Access Compliance Report Public Rights-of-Way (Curb Ramps)

Main Street: WALDEN_ST Cross Street: LAURELHURST_ST Location: NW

ADA ID: RPRK211118115115 Ramp Type: Type 4 - Parallel Initial Pass/Fail: Pass Overall Compliance: No Severity Score: 25

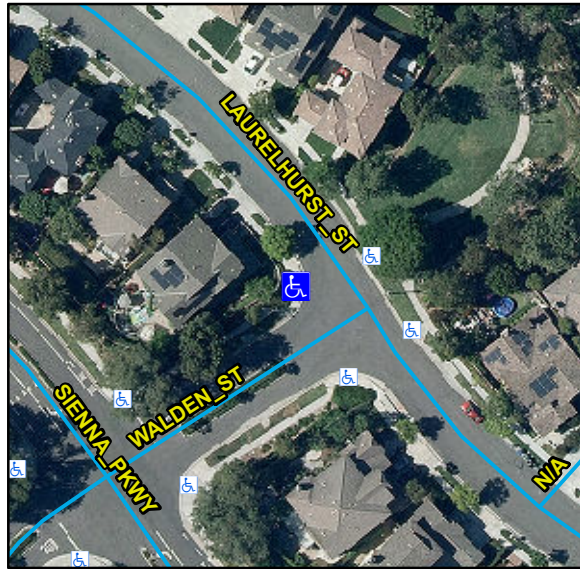
Compliance	Description	Data	Compliance	Description	Data
N/A	Ramp Length LT (in)	114	N/A	Ramp Length RT (in)	116
Yes	Ramp Width LT (in)	54	Yes	Ramp Width RT (in)	54
Yes	Ramp Run Slope LT (%)	2.9	Yes	Ramp Run Slope RT (%)	4.7
Yes	Ramp Cross Slope LT (%)	0.5	Yes	Ramp Cross Slope RT (%)	0.4
N/A	Landing Present	No	No	DWS Provided	No
N/A	Landing Length (in)	N/A	N/A	DWS Contrast	N/A
No	Landing Width (in)	N/A	N/A	DWS Length (in)	N/A
No	Landing Run Slope (%)	N/A	N/A	DWS Full Width	N/A
No	Landing Cross Slope (%)	N/A		DWS Offset Type	N/A
N/A	Landing Movement Obstructed?	No	N/A	DWS Offset Left (in)	N/A
	Landing Movement Type	Curb	N/A	DWS Offset Right (in)	N/A
N/A	Landing Shared	N/A			
N/A	Clear Space	Yes			
N/A	Clear Space To Crosswalk (in)	48			
N/A	Marked Crosswalk 1	No	N/A	Marked Crosswalk 2	No
	Crossing 1 Direction	S		Crossing 2 Direction	E
	Marked Crosswalk 1 Width (in)	N/A		Marked Crosswalk 2 Width (in)	N/A
N/A	Ramp Inside Crosswalk 1	N/A	N/A	Ramp Inside Crosswalk 2	N/A

Crossing 1 Slope (%)	4		Crossing 2 Slope (%)	1.3
	Crossing 1 Cross Slope (%)	0.3		Crossing 2 Cross Slope (%)	1.5
Yes	Gutter Ponding	No	Yes	Curb Slope	7.2
Yes	Gutter Lip Height (in)	0		Road Run Slope (%)	1.5
No	Gutter Run Slope (%)	9		Road Cross Slope (%)	2.3
Yes	Gutter Cross Slope (%)	1.7	No	Perpendicular Joint Present	No
Yes	Overall Surface Condition	Acceptable			
	Cross Gutter Present?	No		Spandrel Present?	No
	Replace Cross Gutter?	N/A		Replace Spandrel?	N/A

Remove & Replace Curb Ramp With Two New Directional Ramps or Equivalent. Remove & Replace Gutter.
